Model: K-C3 (Fax Option)		Date: 19-Jun-07	No.: MB245012
Modified Article: Parts Catalog Correction		Prepared by: M. Ishihara	
From: 1st Tech. Support Sec. Service Support Dept.			
Reason for Modification:	<input checked="" type="checkbox"/> Parts catalog correction <input type="checkbox"/> Vendor change <input type="checkbox"/> Other <input type="checkbox"/> To facilitate assembly <input type="checkbox"/> To improve reliability <input type="checkbox"/> To meet standards <input type="checkbox"/> Part standardization <input type="checkbox"/> Product Safety ()

1.Fax Option (B868)

Model: Model K-C3 Fax Option		Date: 6-Jul-07	No.: MB868001
Modified Article: Parts catalog correction		Prepared by: Y.Yoshida	
From: 1st Tech. Support Sec. Service Support Dept.			
Reason for Modification:	<input checked="" type="checkbox"/> Parts catalog correction <input type="checkbox"/> Vendor change <input type="checkbox"/> Other <input type="checkbox"/> To facilitate assembly <input type="checkbox"/> To improve reliability <input type="checkbox"/> To meet standards <input type="checkbox"/> Part standardization <input type="checkbox"/> Product Safety ()

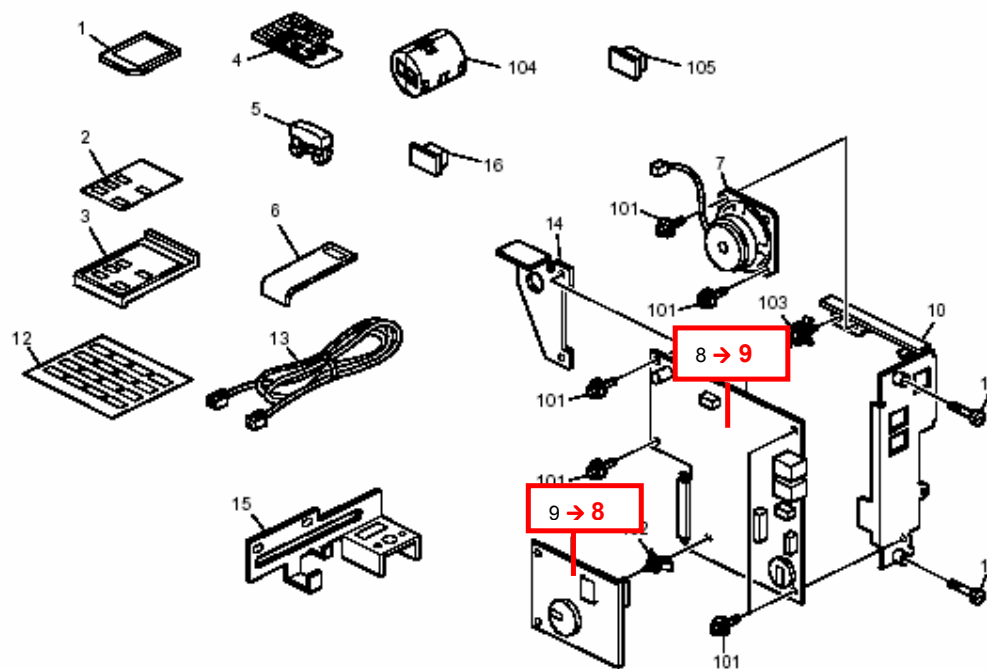
Old part number	New part number	Description	Q'ty	Int	Page	Index	Note
B8685080	-	PCB : MBU : Ass'y	1	-	2	9→8	
B8685172	-	PCB : GWFCU3 : NA	1	-	2	8→9	
B8685174	-	PCB : GWFCU3 : EU	1	-	2	8→9

Change/Reason: Indexes #8 and #9 in the illustration below were corrected (swapped).
